HumeLink

Amendment Report

Rev 0

May 2024

Figure 3-5d: Nominated access tracks

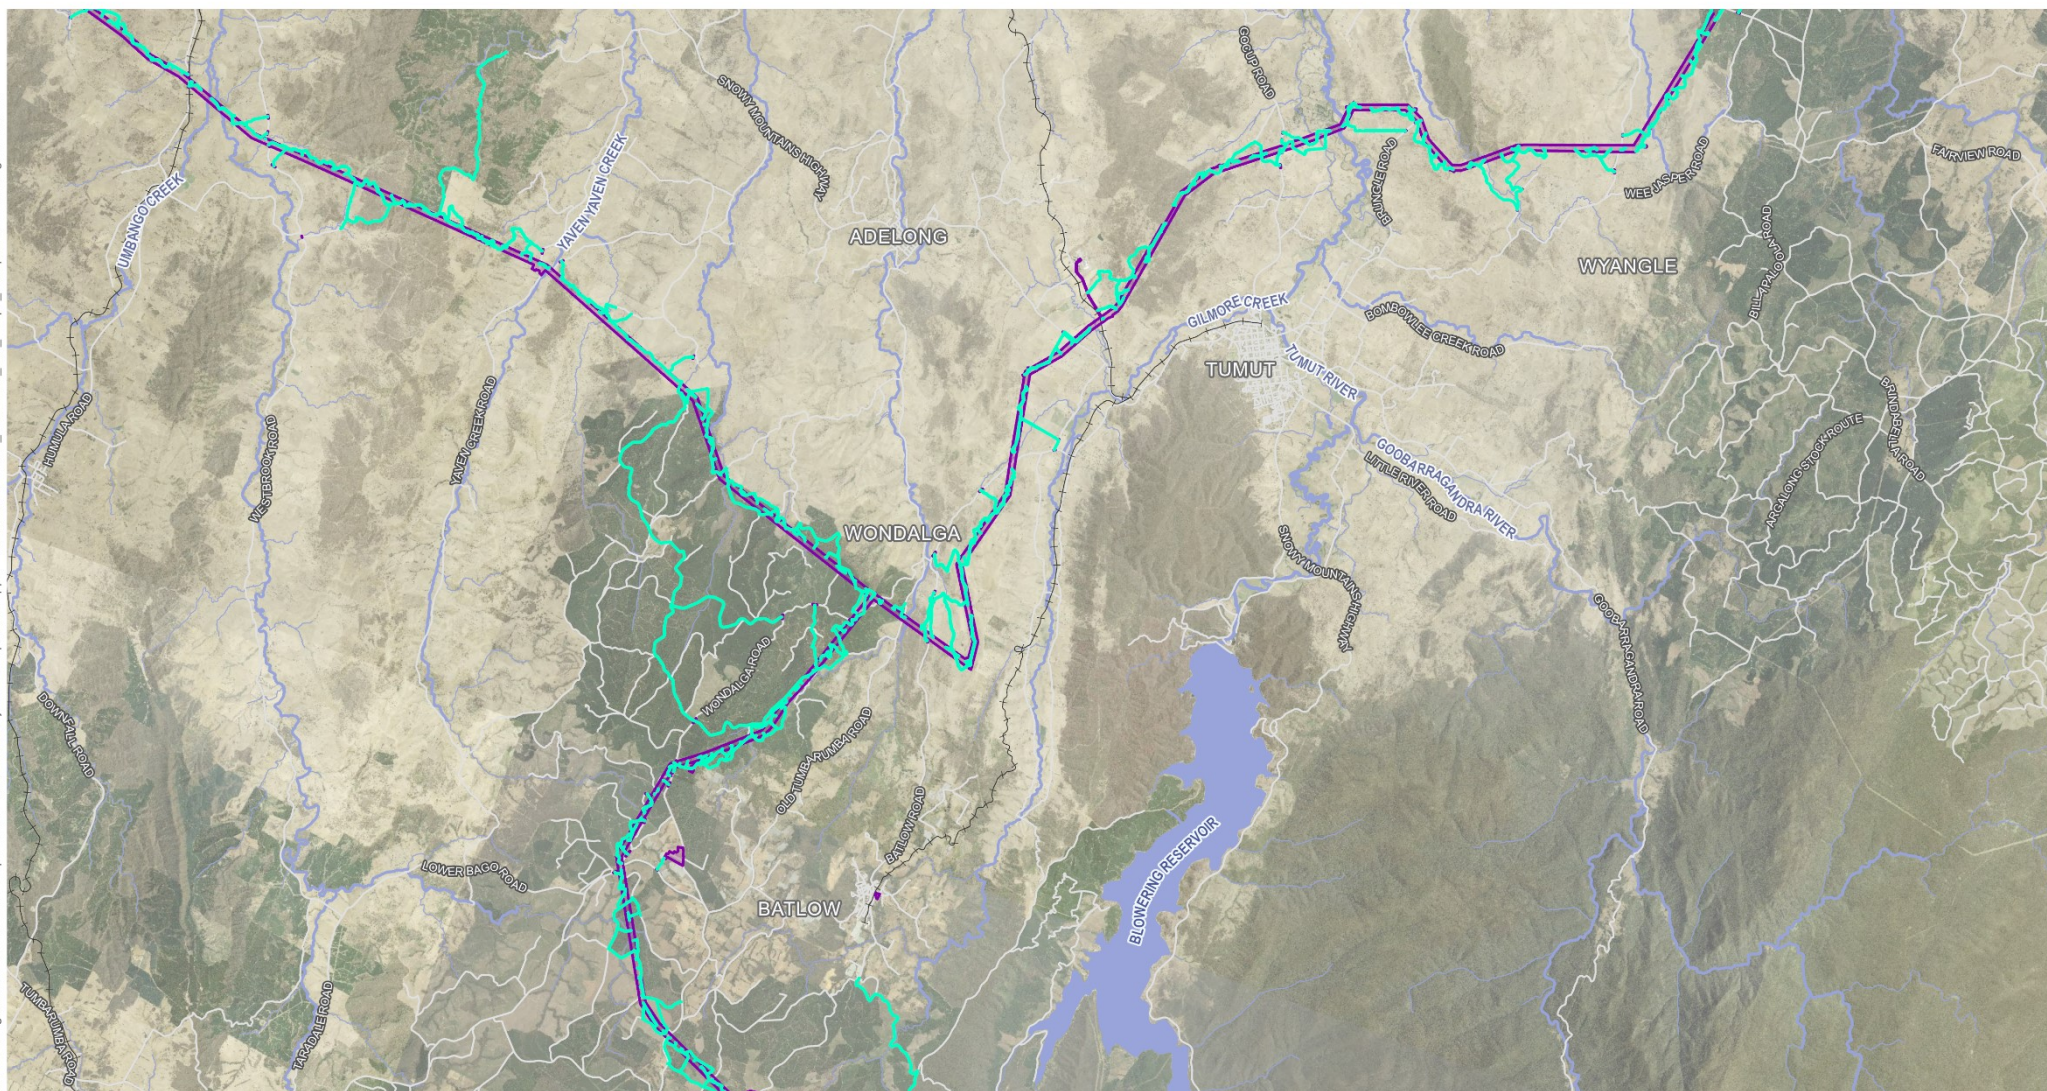
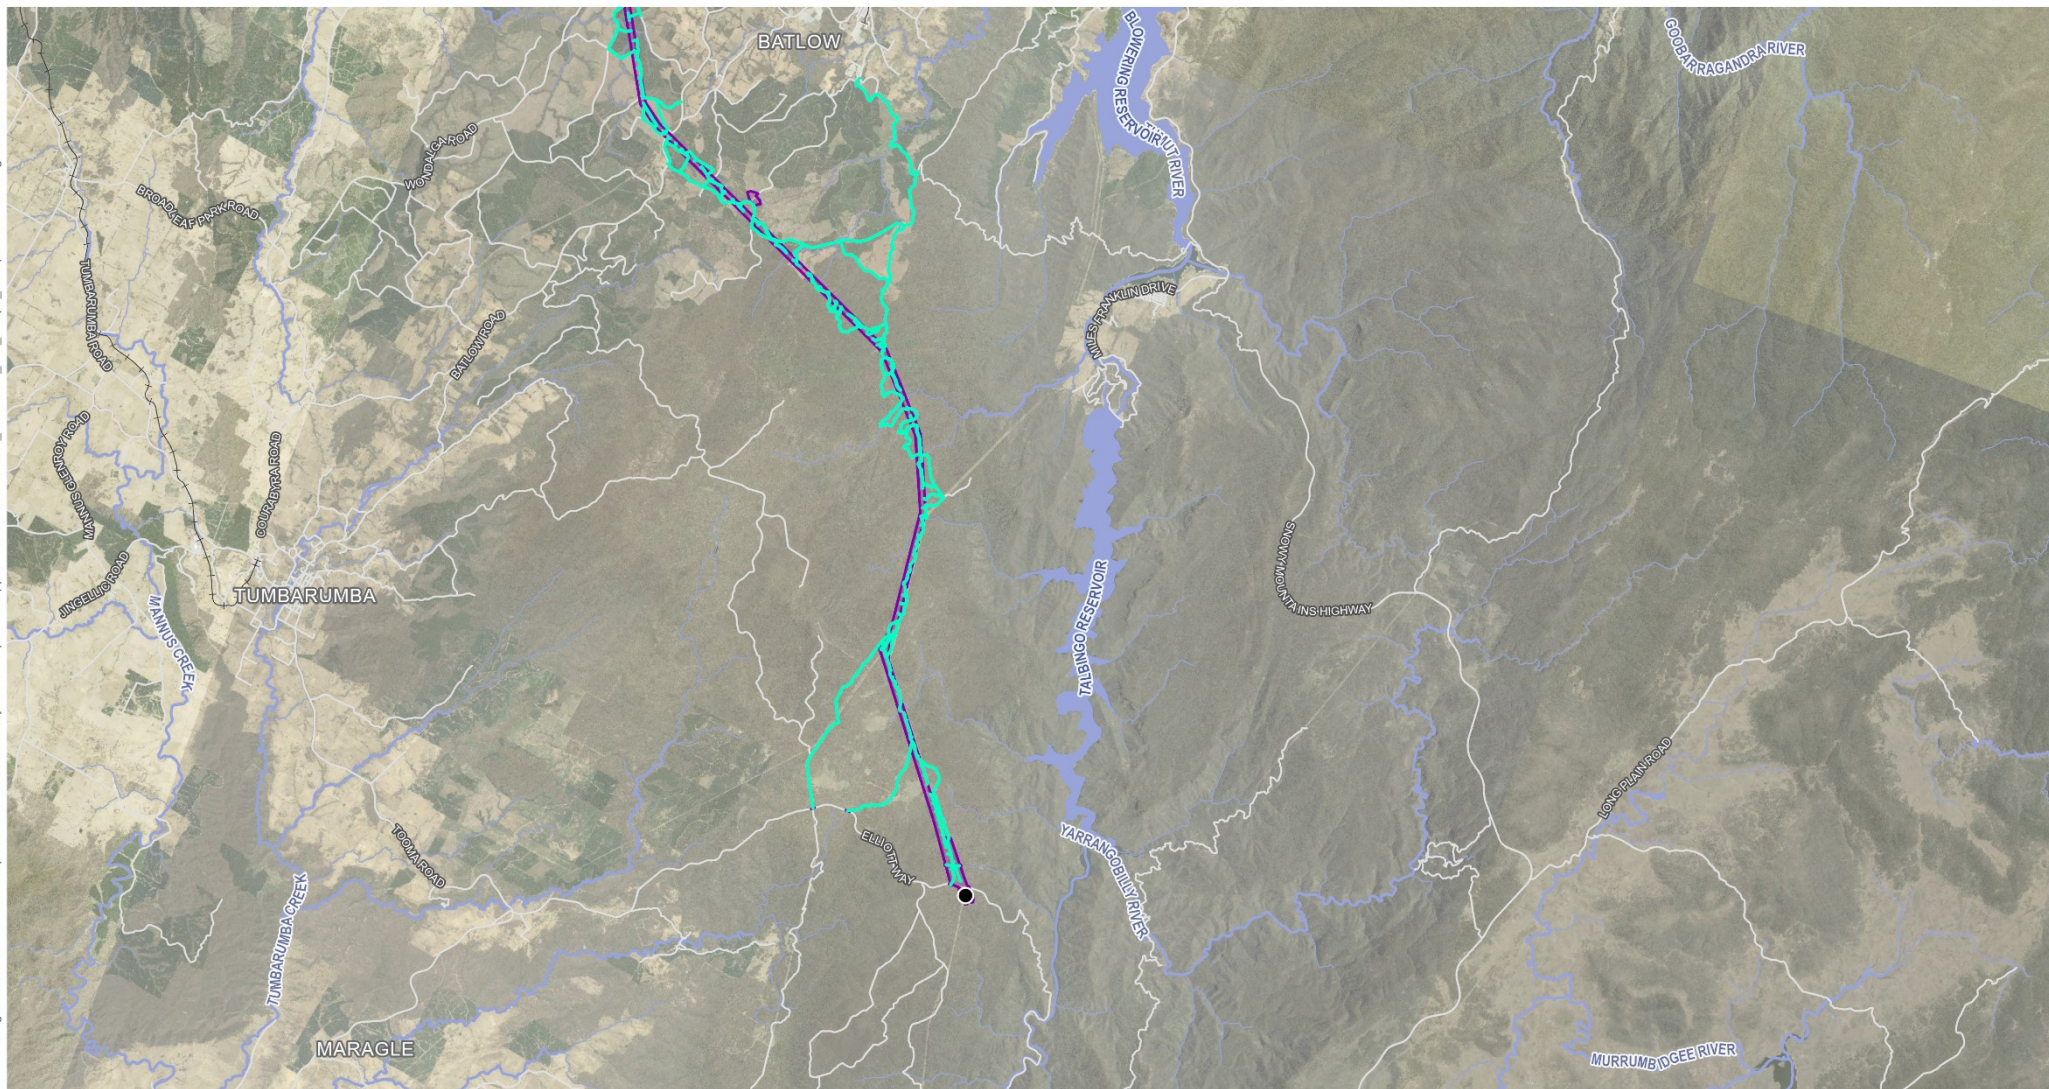
Table 3-5 describes the expected work likely to be involved to make the nominated access tracks suitable for heavy vehicle movements. The full extent of work would be confirmed following further review and survey of the nominated access tracks. Figure 3-5 shows the location of the nominated access tracks along the project footprint.

New tracks	<p>The locations of new access tracks have generally been selected in consultation with affected landowners to minimise property impacts, including running the track along fence lines, using movement paths preferred by landowners, and going through existing property gates.</p> <p>Establishing the new tracks would typically include earthworks, grading, drainage work and construction of waterway crossings. Fill material may be imported to provide a suitable capping material.</p> <p>To establish the new tracks, vegetation clearing or pruning/trimming may be required. The total clearing width would generally be up to 10 m, with some limited areas (eg steep terrain) requiring a clearing width of up to 20 m for batters.</p>

FIGURE 3-6: Additional telecommunications connections to existing substations

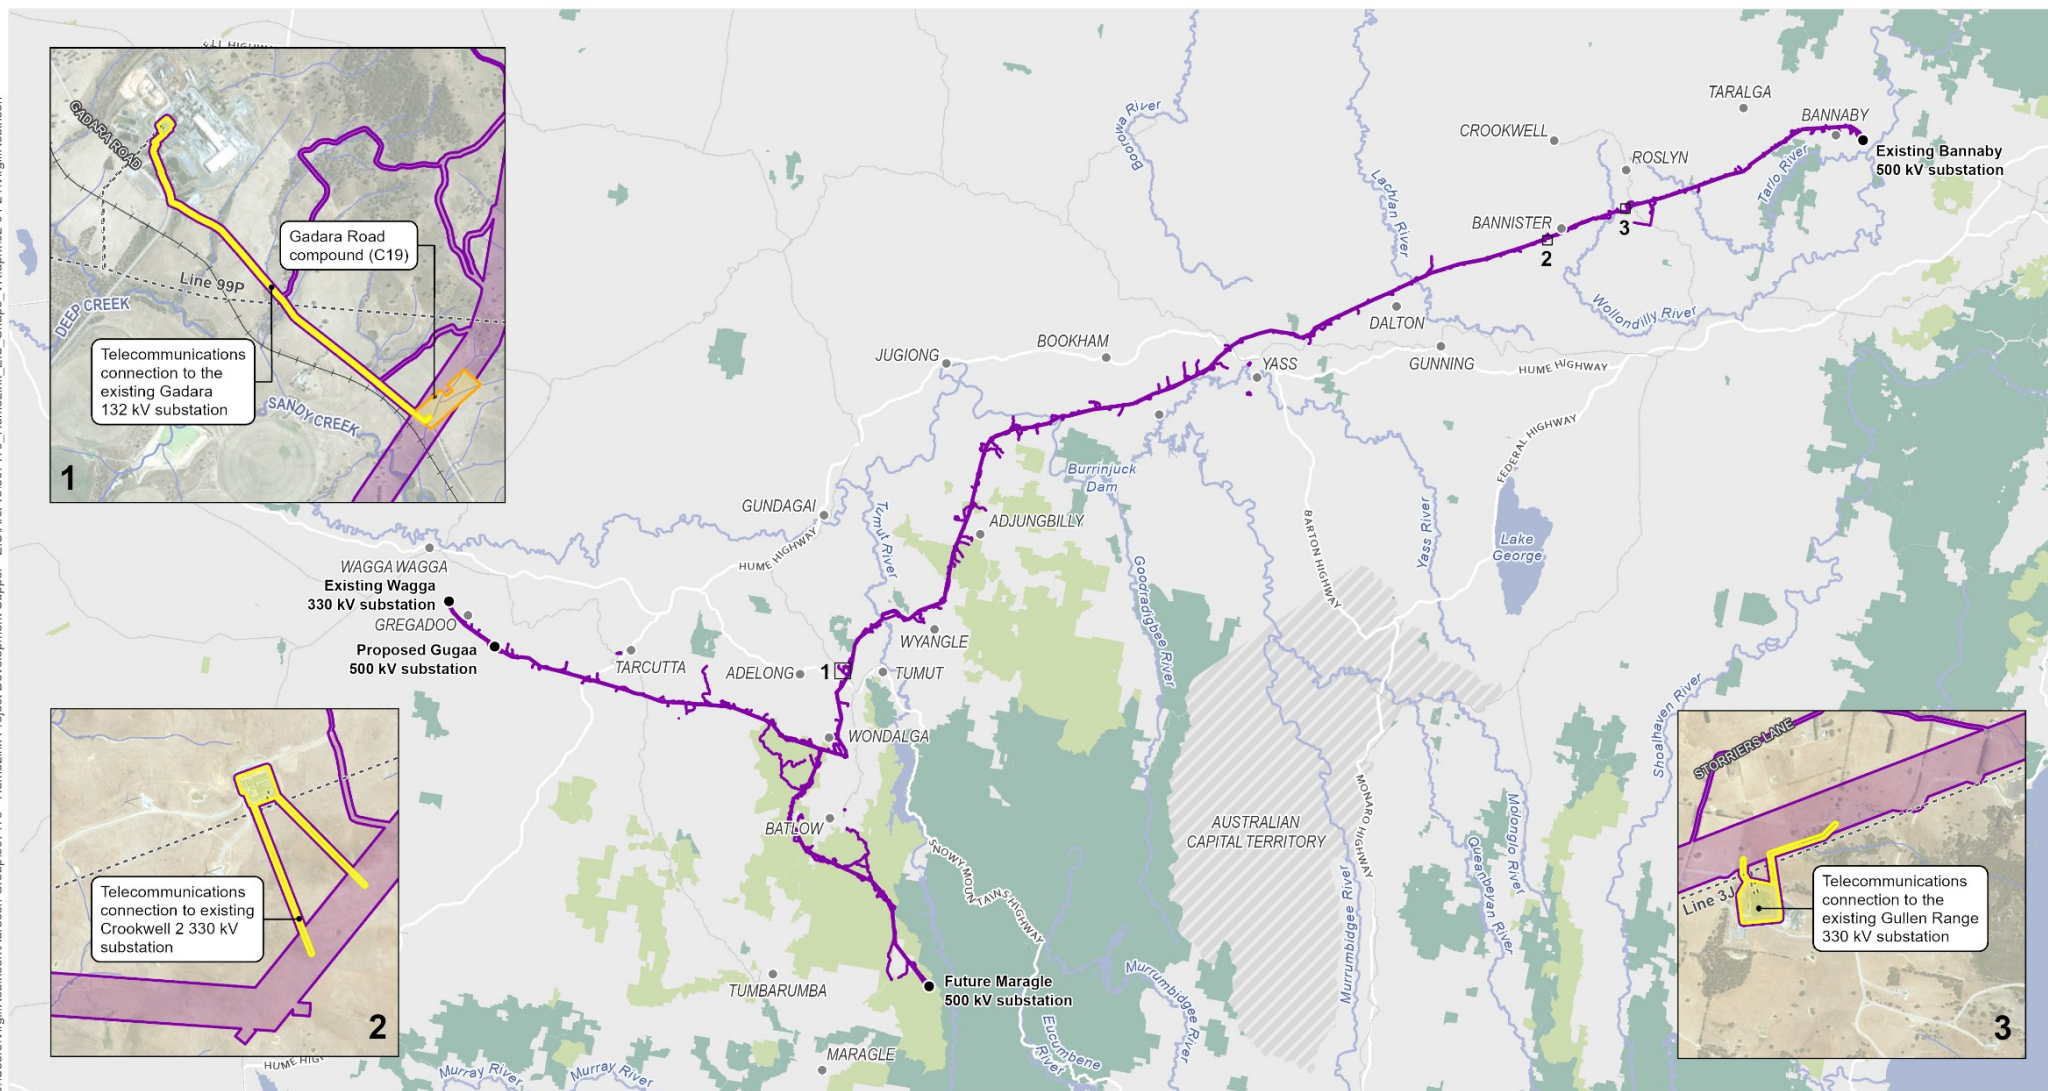
Work associated with the new telecommunications connections would involve excavating to an appropriate depth (ie generally between 0.6 metres to 1.2 metres). Once the appropriate depth is reached, the underground fibre optic cable and conduit would be installed, and the trench backfilled accordingly with excavated material or a sand/cement mix if additional protection is required. Cable pits and marker posts would also be installed where needed. Work associated with the connection to Gadara 132 kV substation would be carried out under traffic control as required.

Figure 3-6 shows the locations of additional telecommunications connections to the substations along the transmission line corridor.

Figure 3-7 Substation design refinements at the proposed Gugaa 500 kV substation

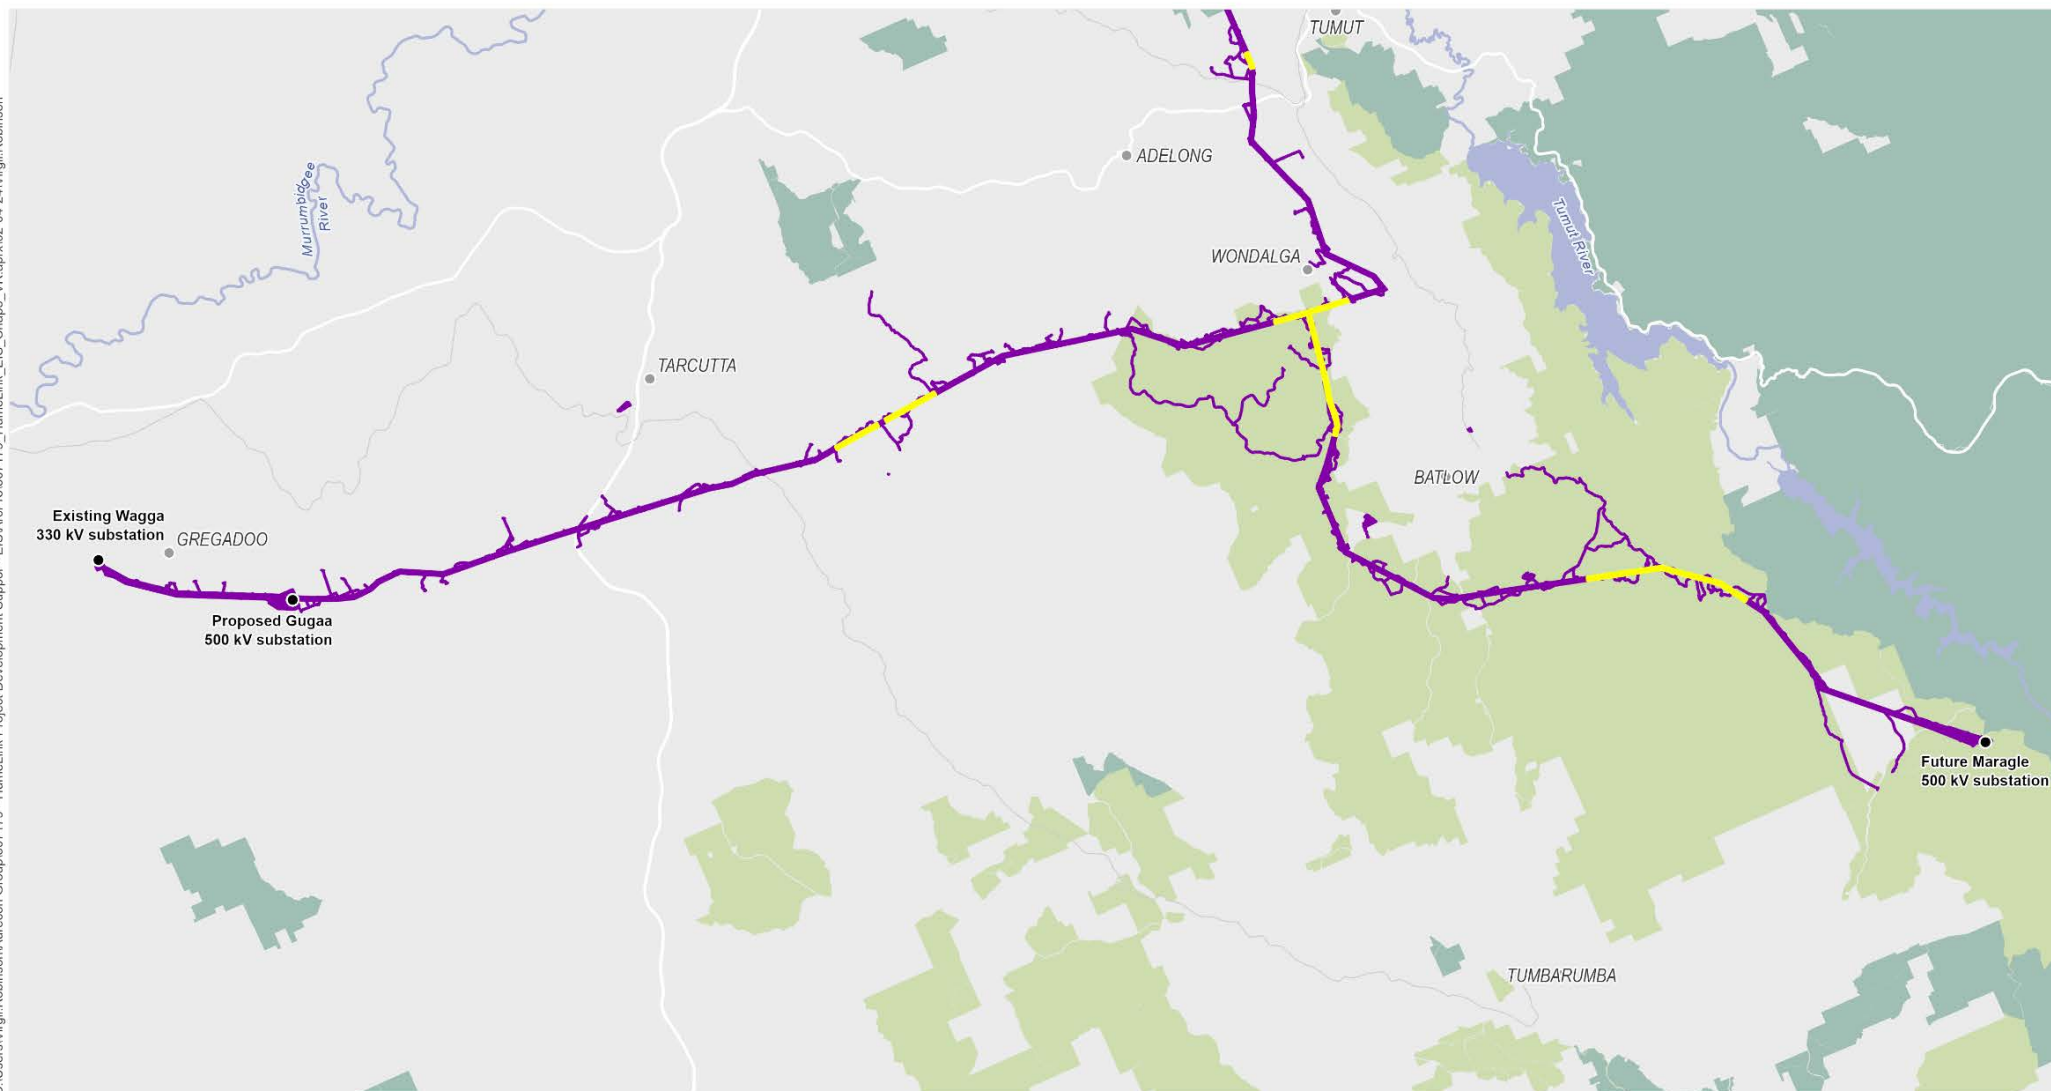
Figure 3-7 shows the refined layout to the proposed Gugaa 500 kV substation.
